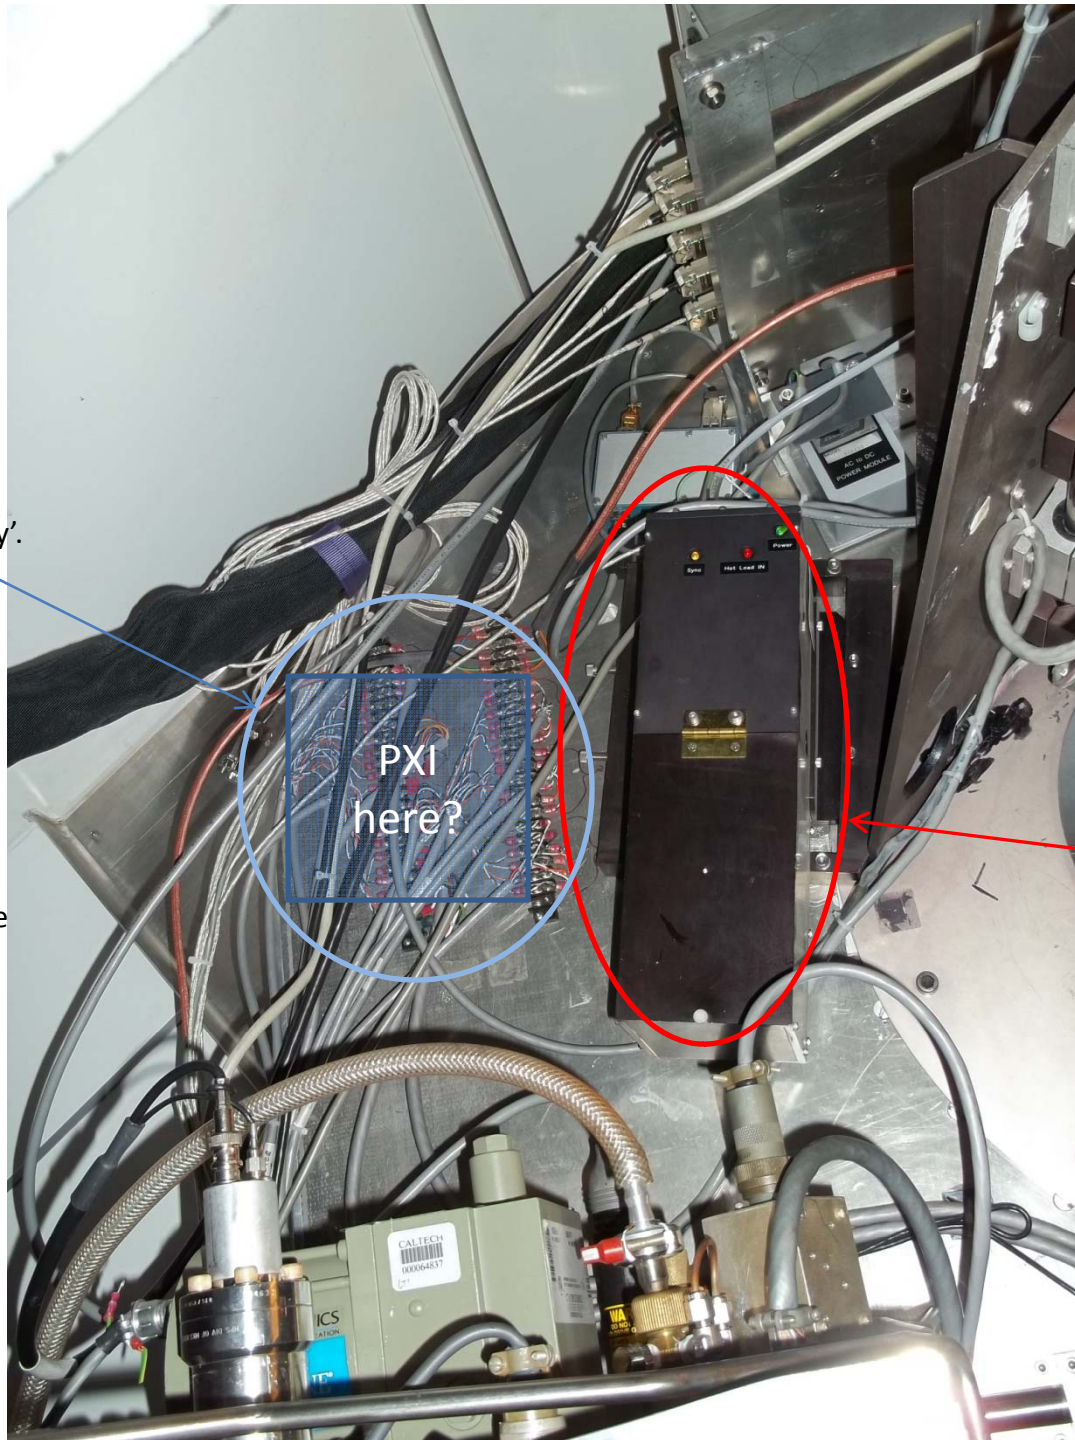
This has always
been there from
The beginning of time
or since 'Budha was a baby'.
(< 1990)

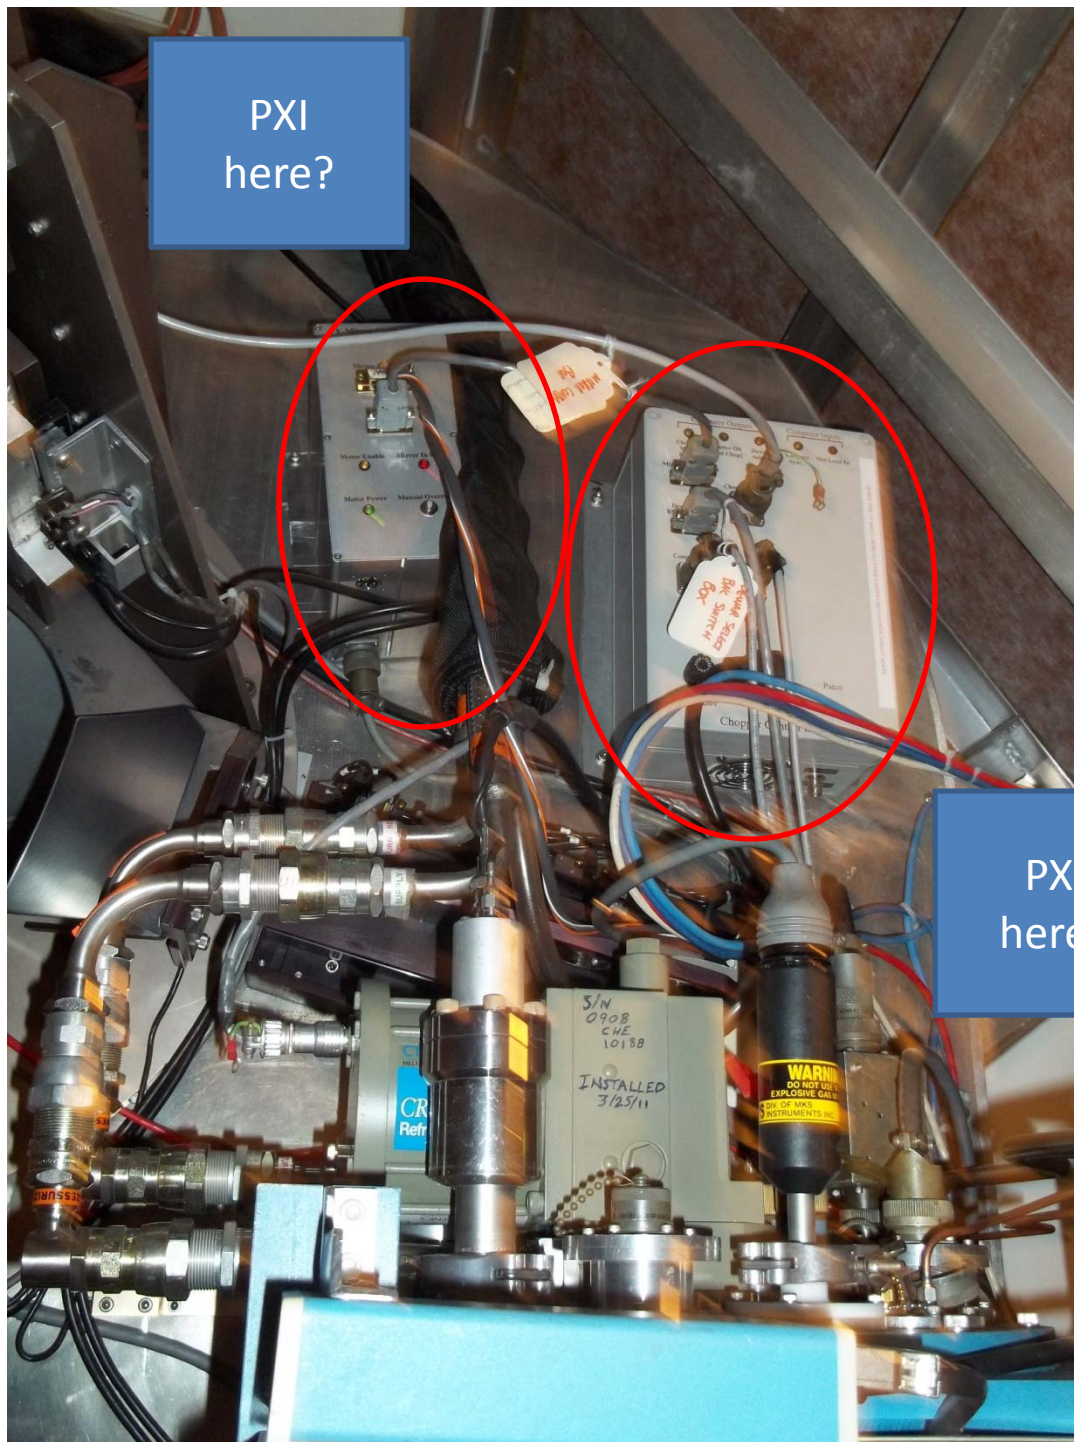
It can be moved. It has
Nothing to do with the Rx.
Maybe it is the mirror
Motor control or
focus control
(stepper motors).

We can clean this when the
Dewar is pulled off I
Imagine.

Old Cold load.
Defunct. But the
Octagon software
Needs it to operate
I think. → Space will
be freed up once
The new Rx come out.

You can try disconnecting
the DB-9 connector and
See if the octagon
Handheld boots up/freezes.

PXI
here?

PXI
here?

Both are control boxes used by the Octagon software. Will be removed once the dewars are replaced. I think the Octagon software expect them. e.g. freezes w/o these boxes.

This shows one of the problems of having two completely different Systems (Octagon vs PXI and Gunn vs Synthesized LO). Better to swap everything out at once if at all possible.

So yes, once again the Lhe fill clearance problem. Keep in Mind the PXI crate connectors (2-3") will stick out and are very vulnerable. maybe mount the PXI crate off to the side?
